Permit Application Review

Permit No. 2021-117
Received complete: October 11, 2021

Applicant: Deb Williams: City of Bloomington
Consultant: TJ Rose; Larson Engineering, Inc.
Project: Reconstruction of Bloomington Fire Station #4
Location: 4201 West 84th Street: Bloomington
Rule(s): 4 and 5
Reviewer(s): BCO

CNH NO.: 19116
DATE: 08/17/21
GRADING AND EROSION CONTROL PLAN

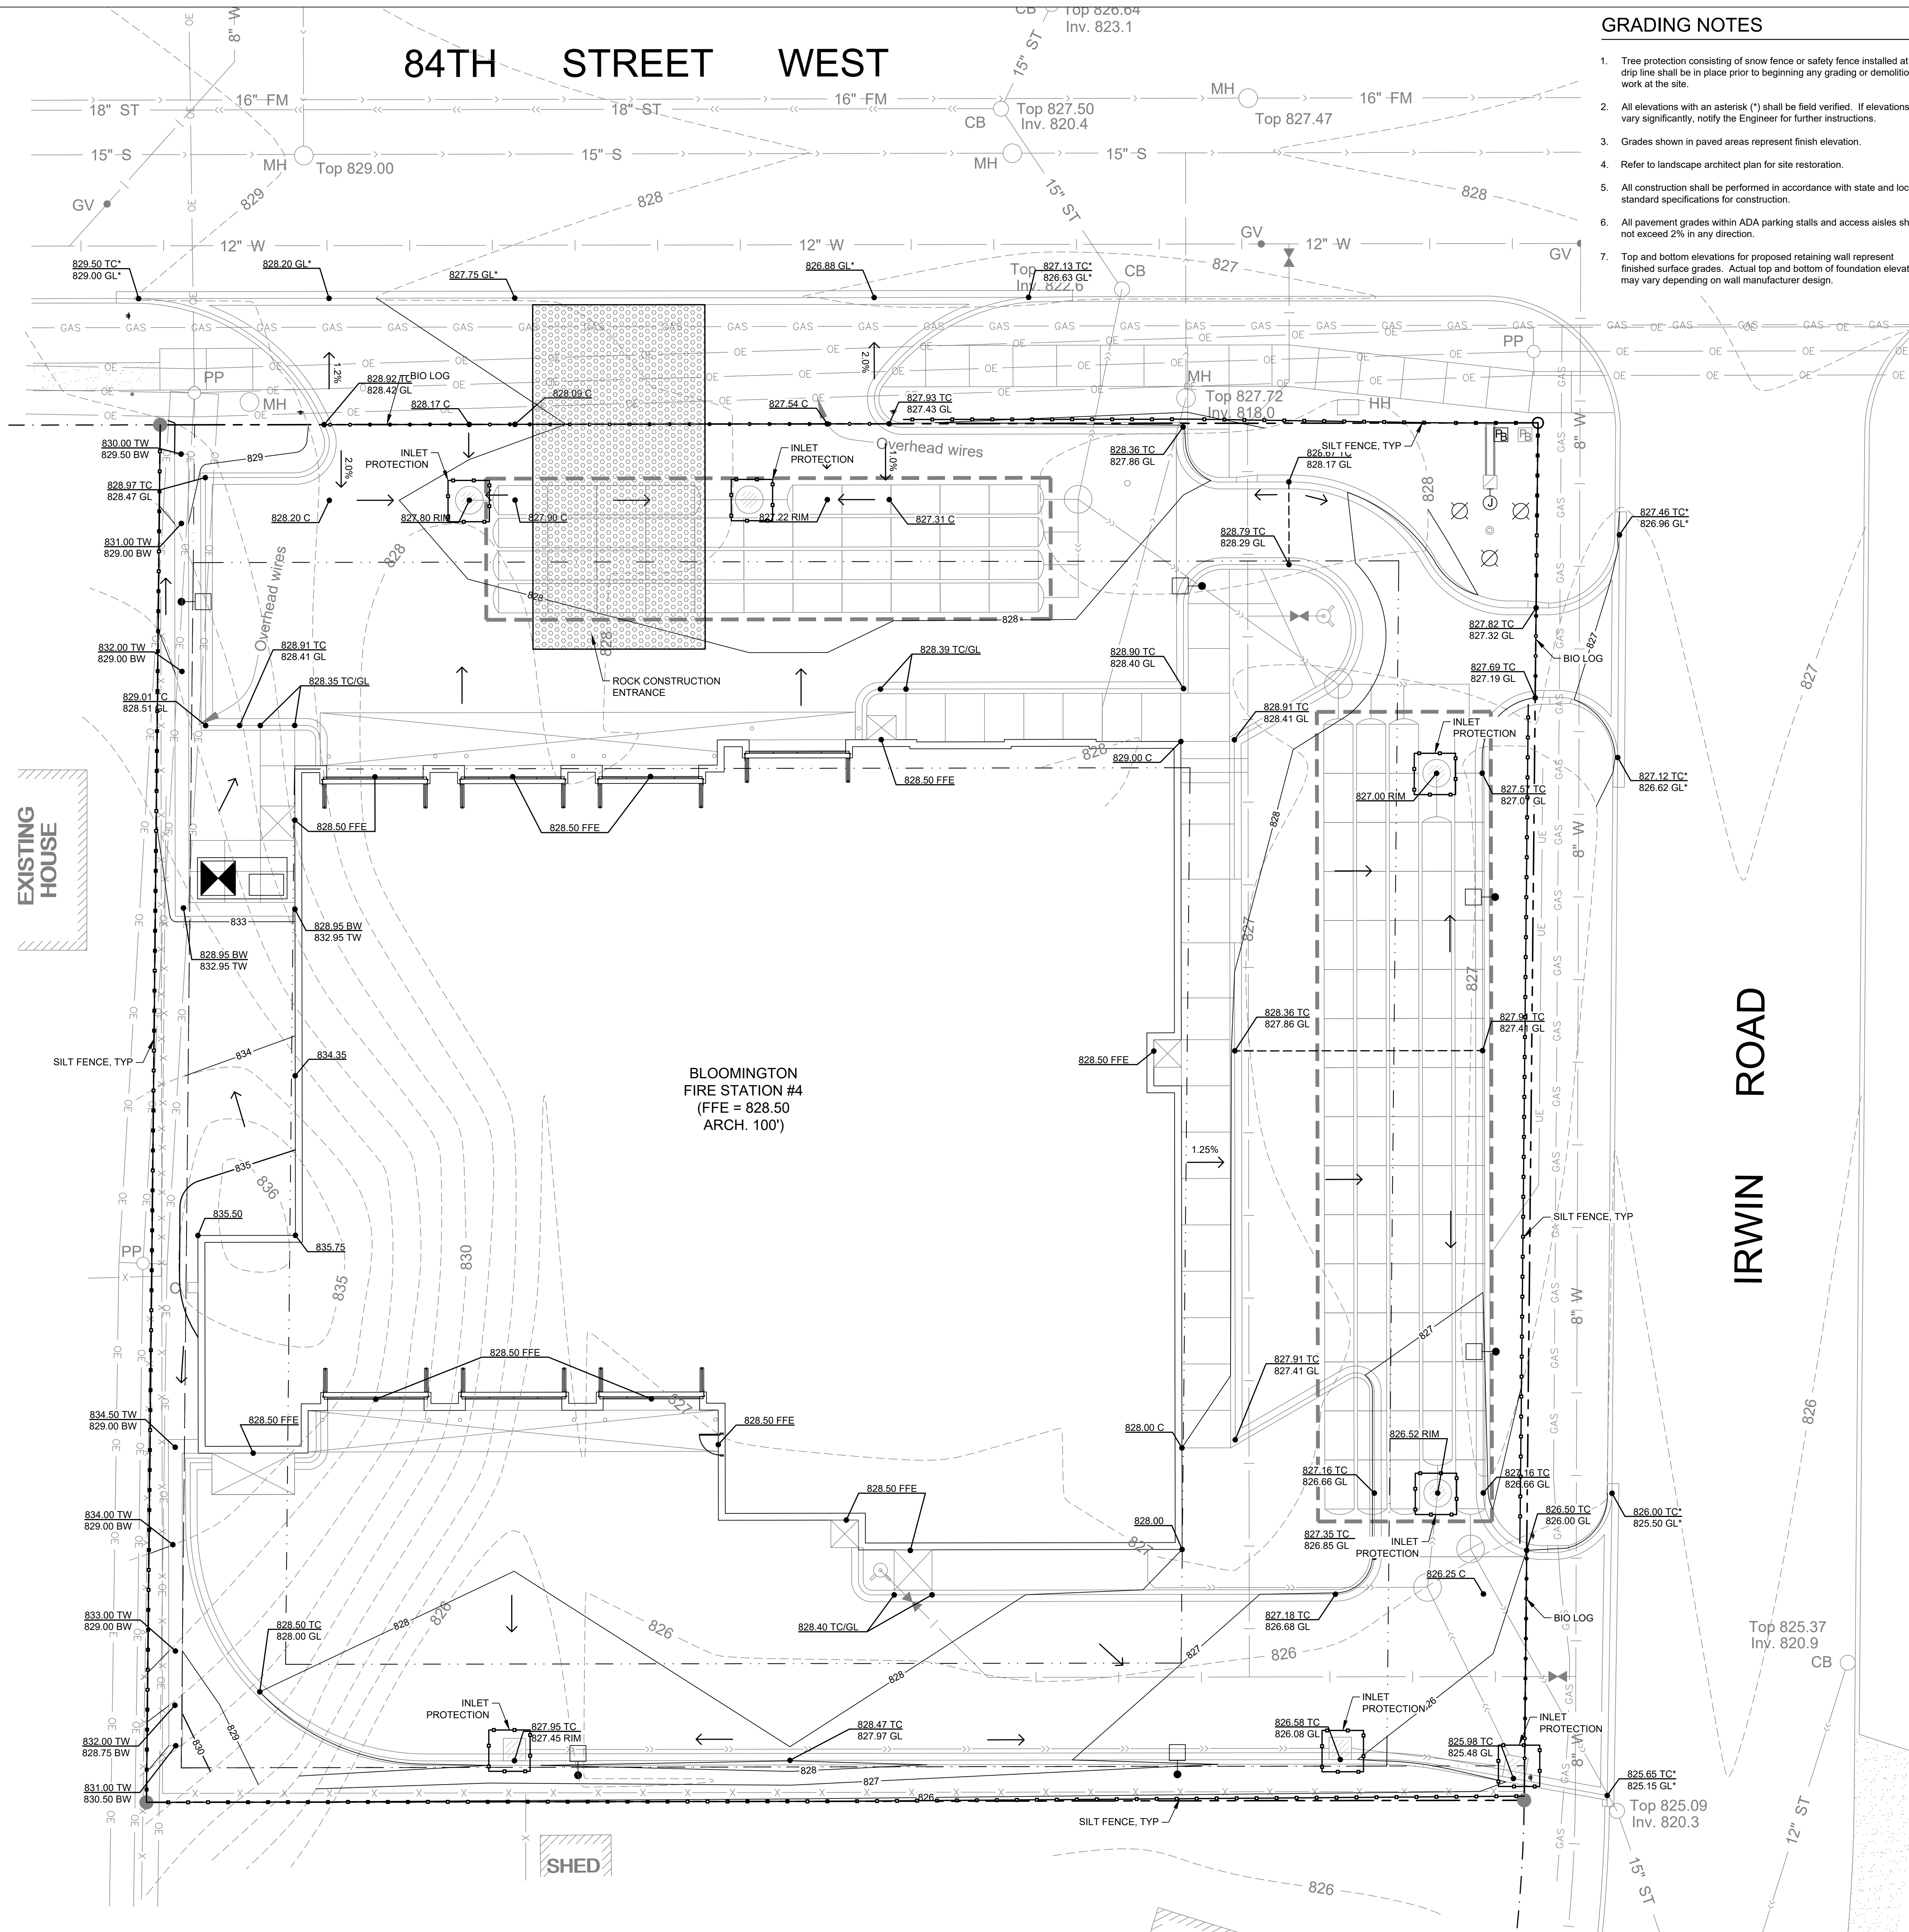
For pre-treatment of runoff prior to discharging to the underground filtration facility, sumps within catch basins upstream of the underground system and an isolator row within the system are to be provided.

The submitted erosion and sediment control plan includes silt fence at the limits of construction, a gravel construction entrance and storm drain inlet protection. The contractor for the project will need to designate a contact who will remain liable to the District for performance under the District's Erosion and Sediment Control Rule 5.0 from the time the

The applicant providing a name and contact information from the contractor responsible for the erosion and sediment control at the site. NMCWD must be notified if the responsible individual changes during the permit term.
